SUBJECT: O'FALLON COMMUNITY PARK ENHANCEMENTS
NEW POOL AND AMPHITHEATER (PHASE 1)
411 EAST 5TH STREET
O'FALLON, IL 62269

FGM Project No.: 23-3773.01

This Addendum forms a part of the Bidding and Contract Documents and modifies the original bidding documents dated February 14, 2024, and project Addendum #1 documents dated February 26, 2024. Acknowledge receipt of this Addendum in space provided on Bid Form. **Failure to acknowledge addenda may subject bidders to disqualification.**

ELECTRICAL LIGHTING PLAN
 SHEET NO.
E1.1
 JOB NO. 23-3773.01
 © 2024 SSC ENGINEERING, INC.

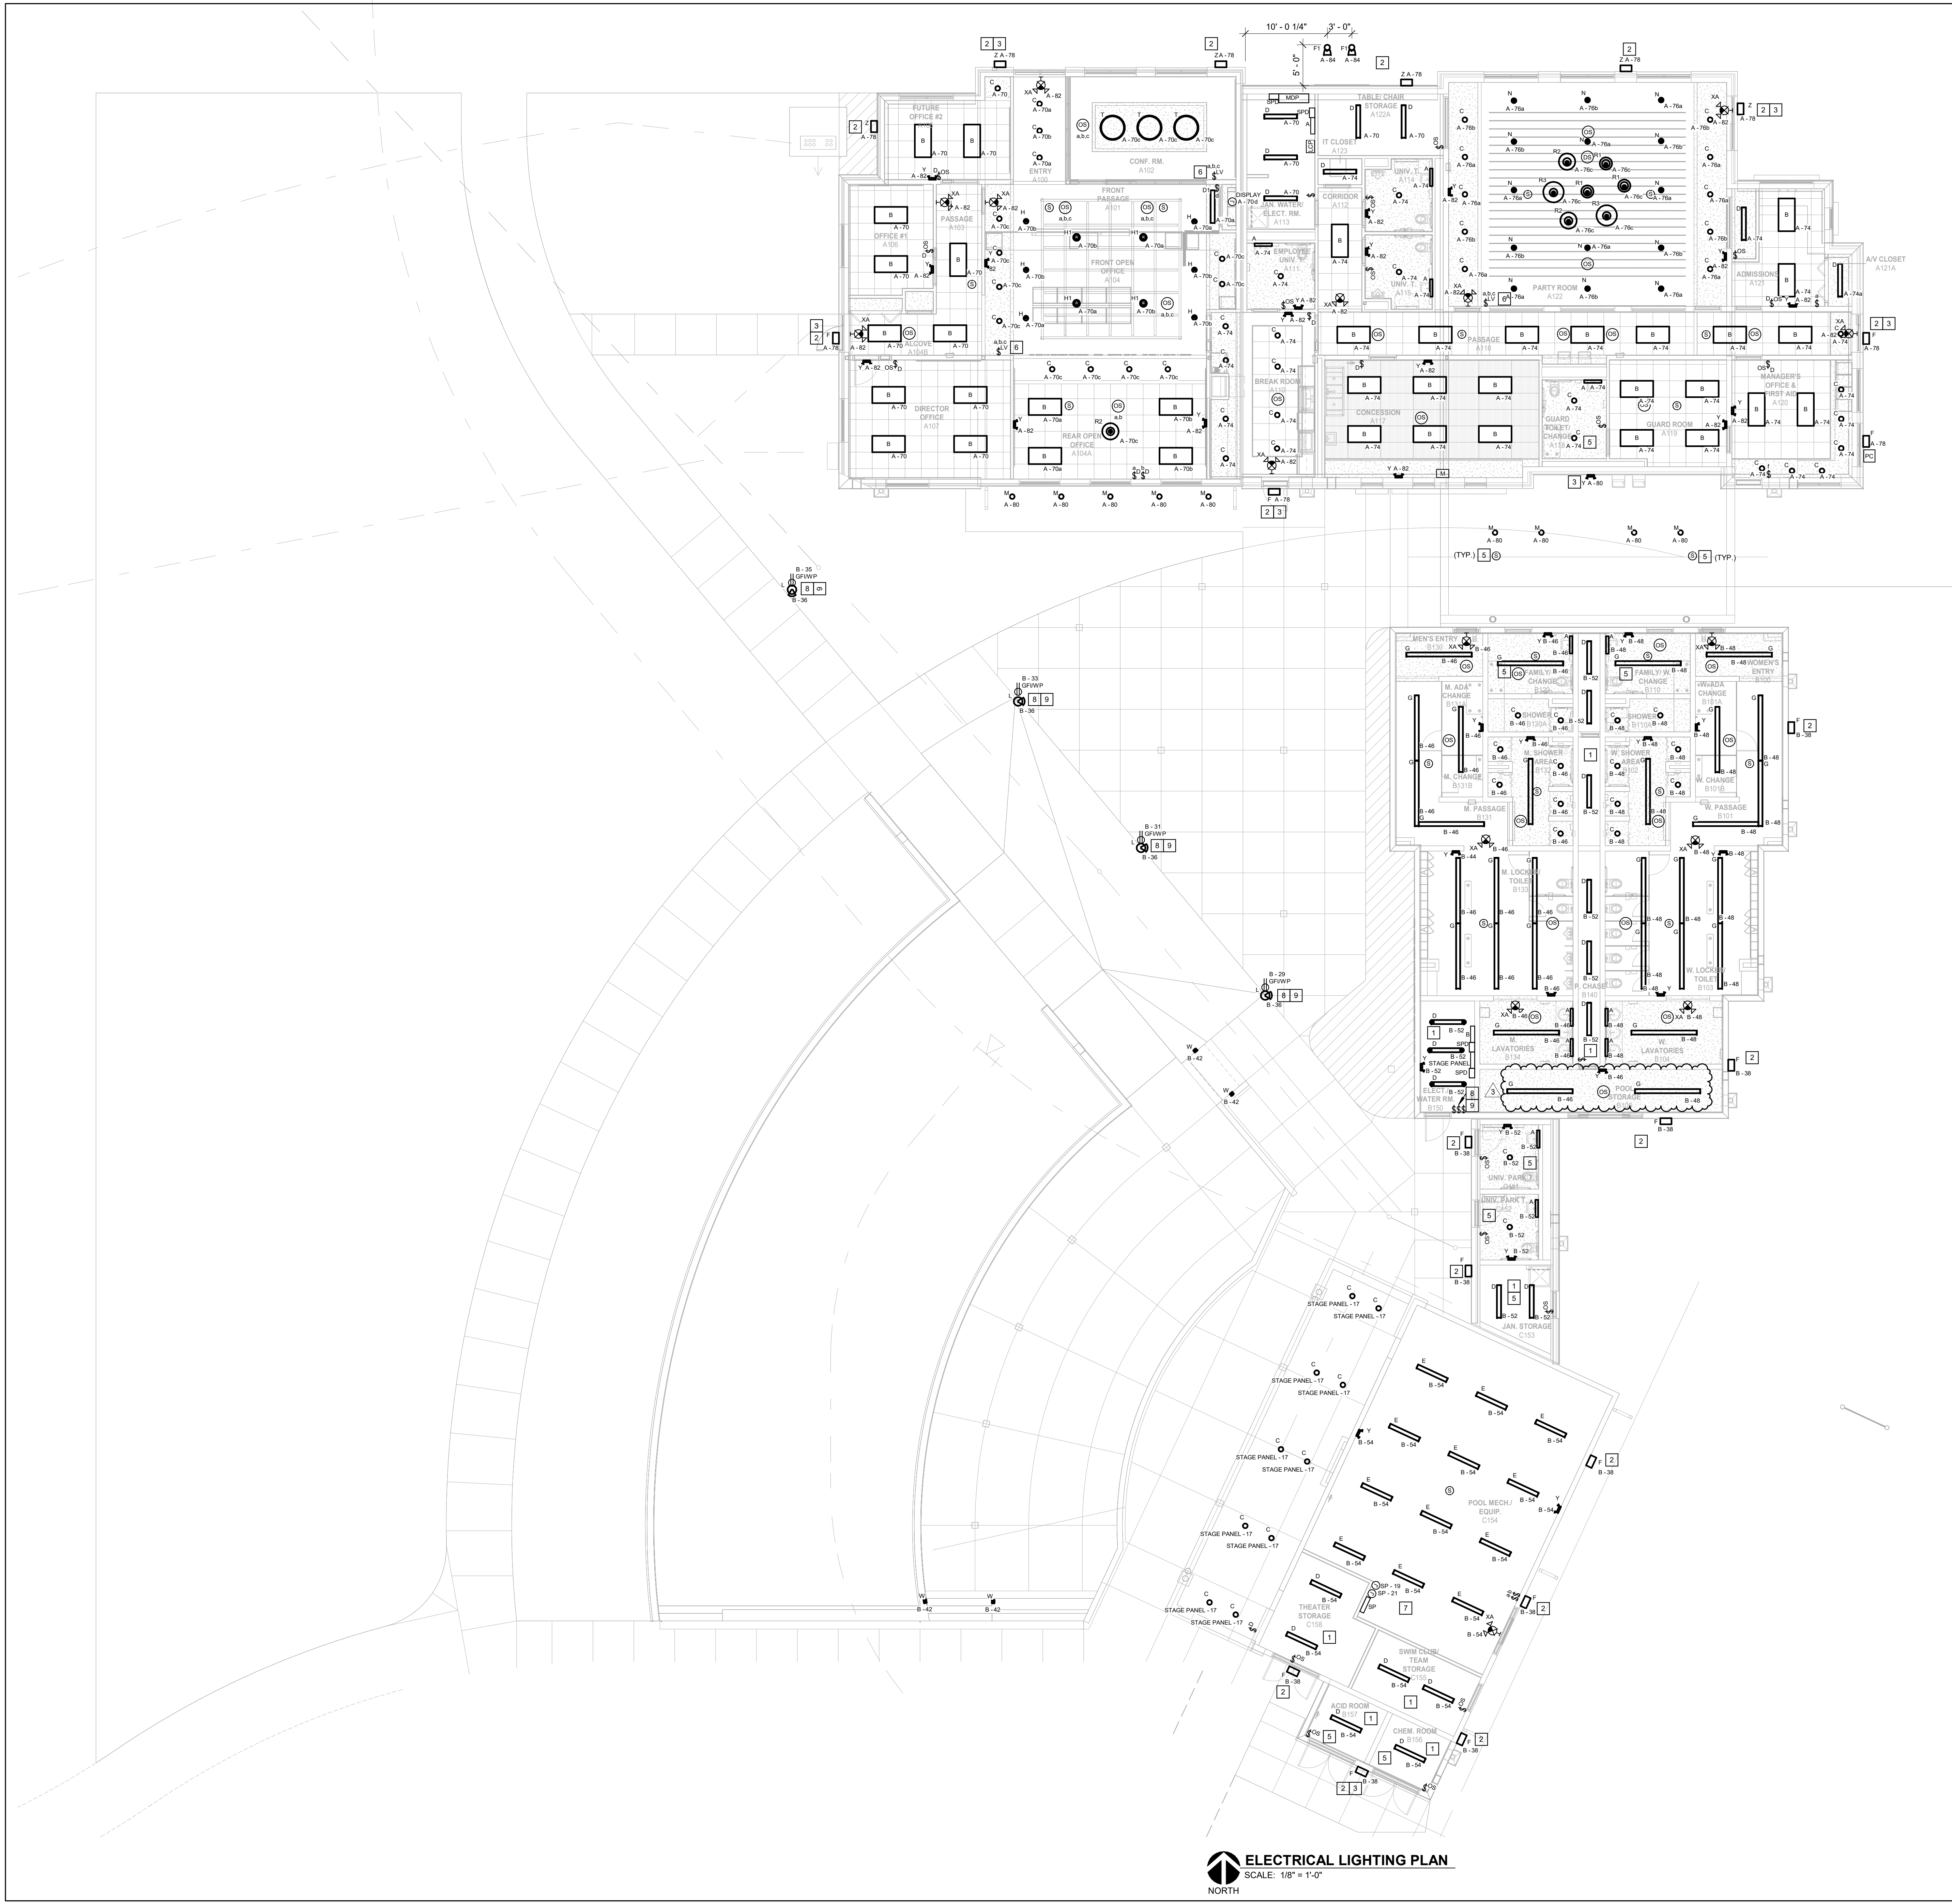
28. SHEET E1.1 – Electrical Lighting Plan (Sheet Reissued)
